DESIGNED: MAB	REVISION:
DRAWN: HIG	
CHECKED: MAB	
DATE: 11/26/18	
RESPEC 3520 AUSTIN BLUFFS PARKWAY SUITE 102 COLORADO SPRINGS, CO 80918 PHONE (719) 266-5212	
STAMP	
811 Know what's below. Call before you dig.	
PROJ NO. 03524 DWG NM. 03524-Dev-Fil2	
Guman & Associates, LLC 731 N Weber St, Suite 10 COLORADO SPRINGS, CO. 80903	
GLENEAGLE SUBDIVISION, FIL #2	
ROADWAY PLAN OVERALL	
DRAWING NUMBER: C	
SHEET 1

VR-18-018

GLENEAGLE
 SUBDIVISION,
 FIL #2

STONE EAGLE PL
 PLAN AND PROFILE

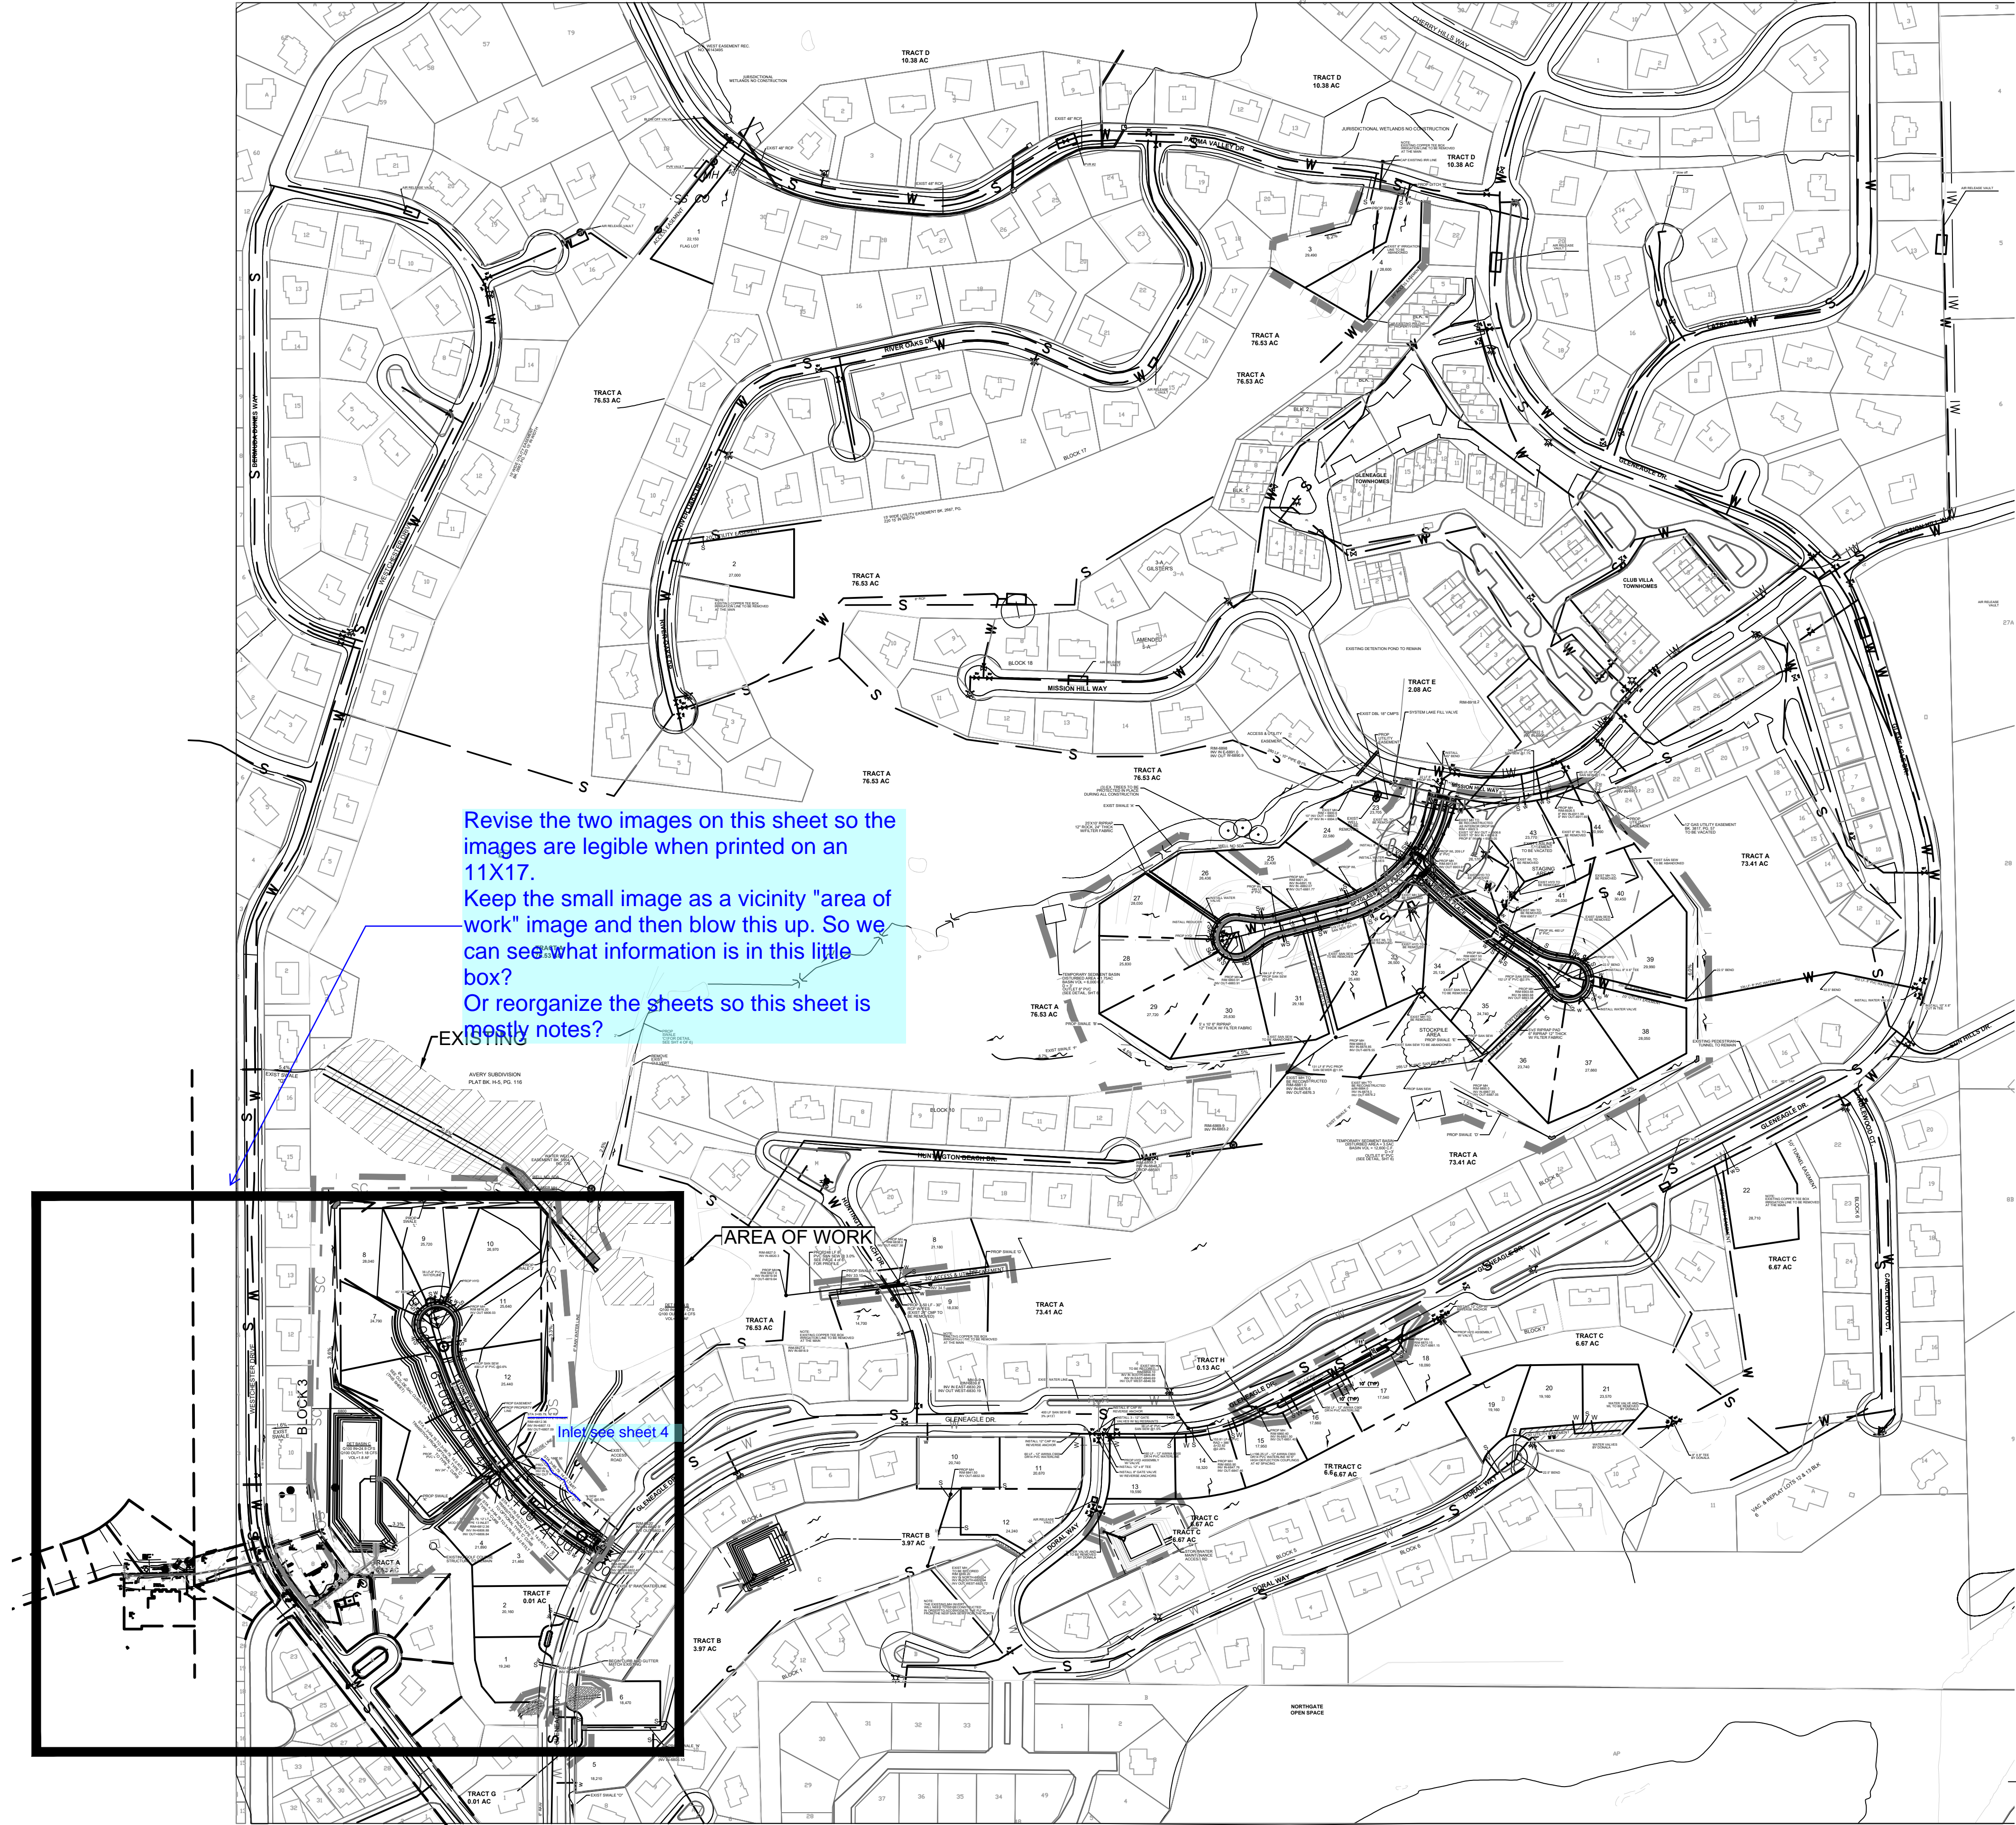
Revise the two images on this sheet so the images are legible when printed on an 11X17.
Keep the small image as a vicinity "area of work" image and then blow this up. So we can see what information is in this little box?
Or reorganize the sheets so this sheet is mostly notes?

SIGNING AND STRIPING PLAN

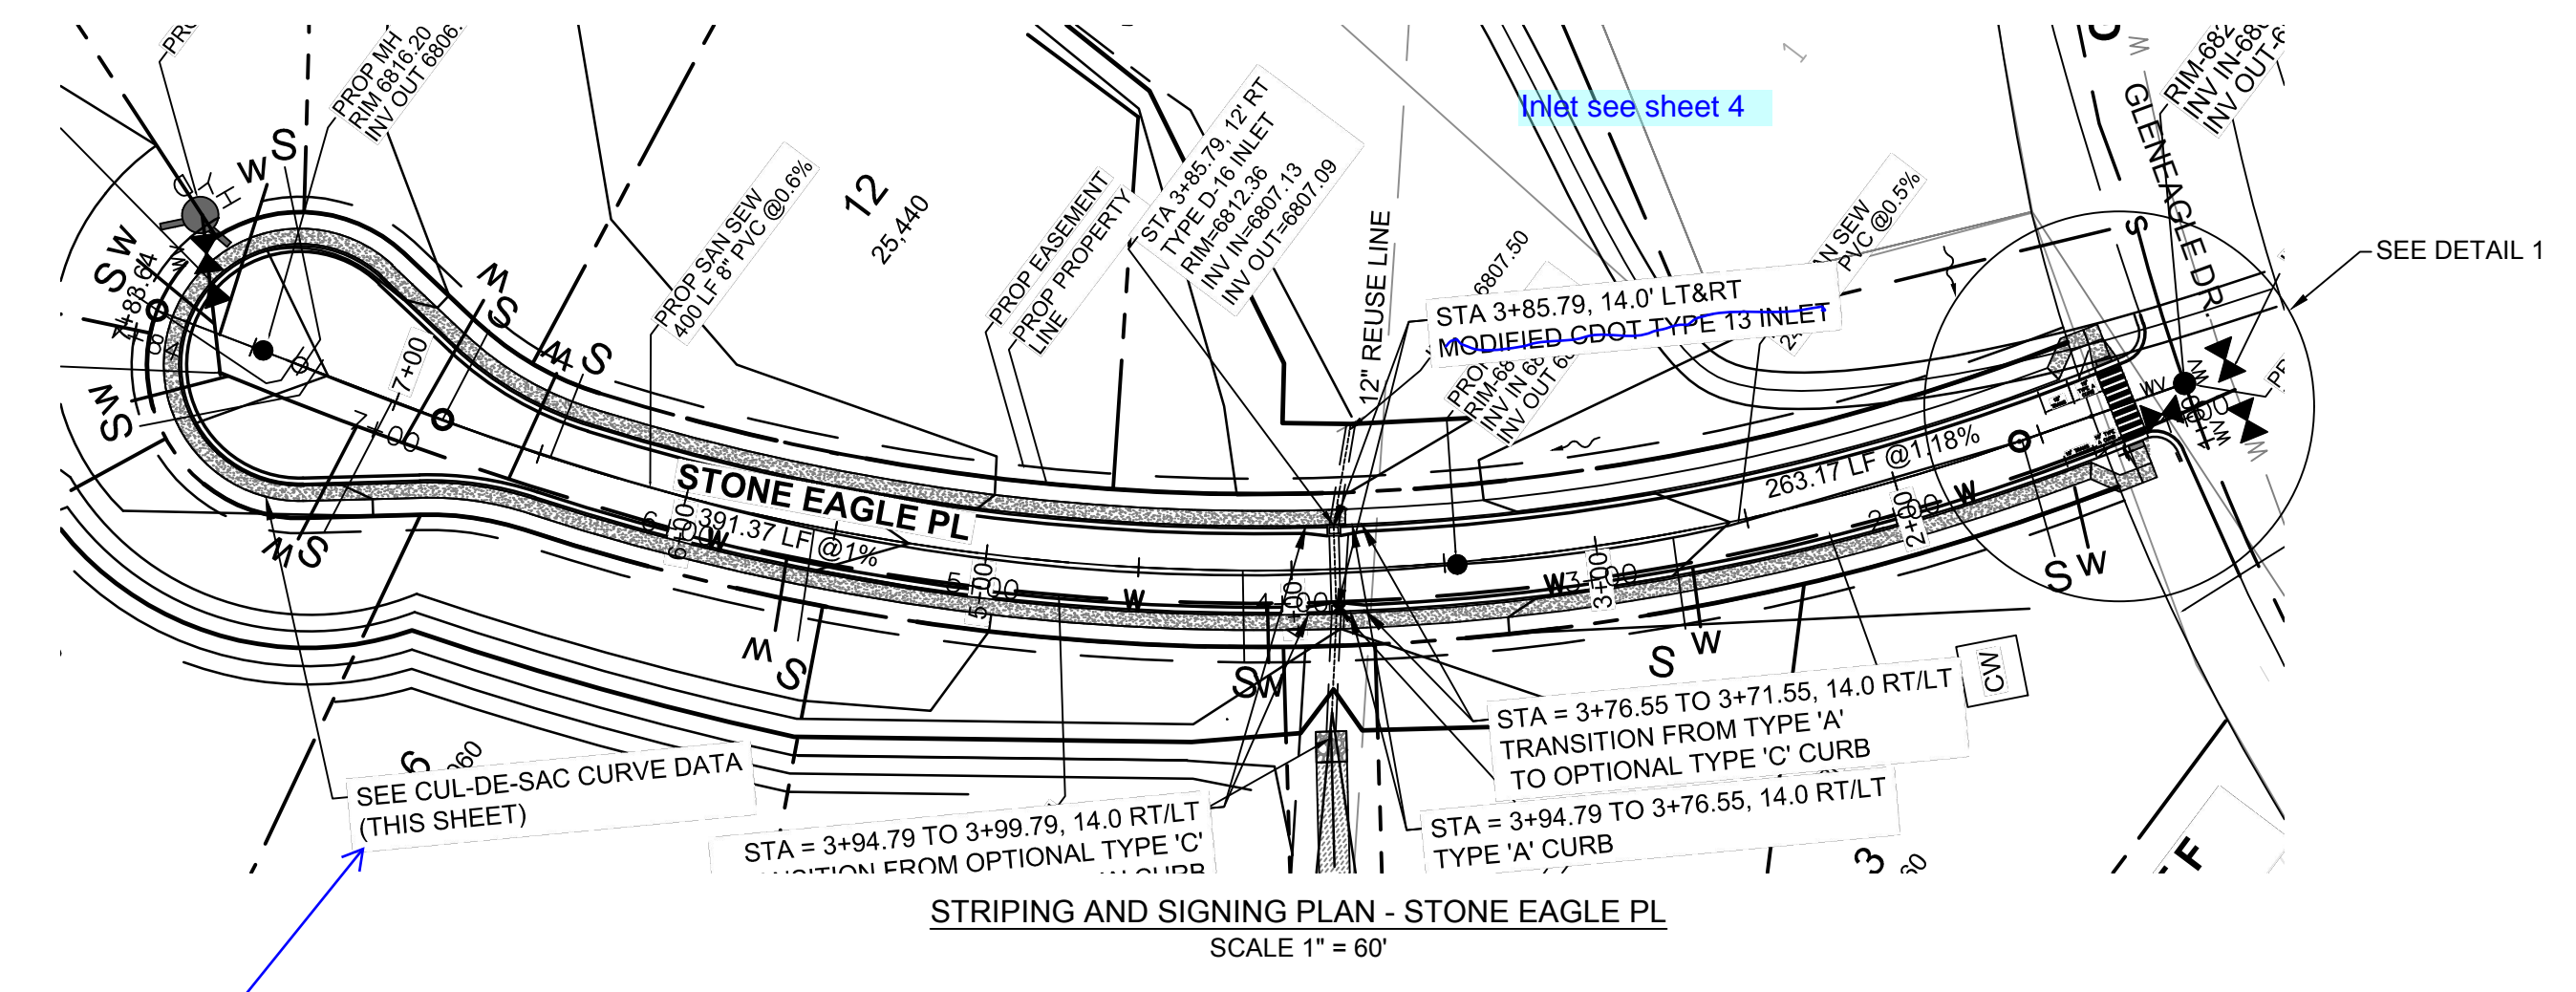
no curve data on this sheet.

Standard Notes for El Paso County Construction Plans

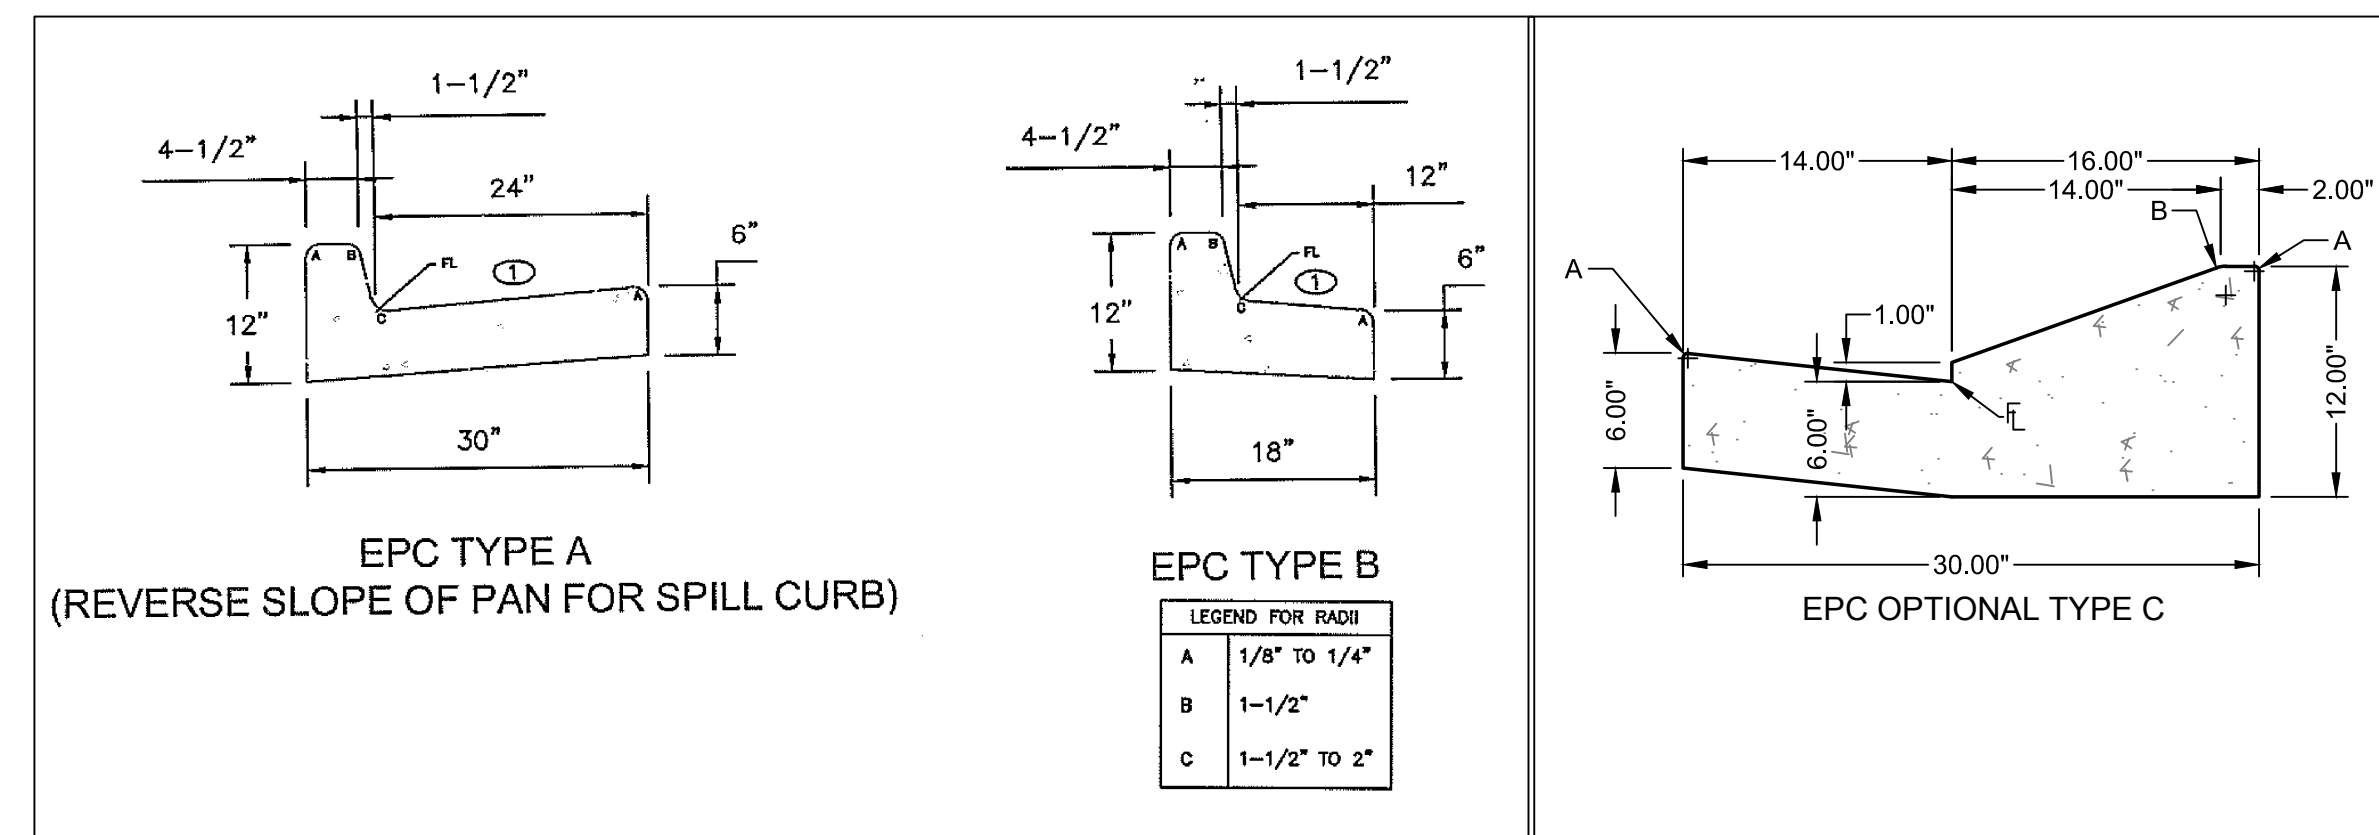
Change Development Services Department (DSD) to Planning and Community Services (PCD) throughout.
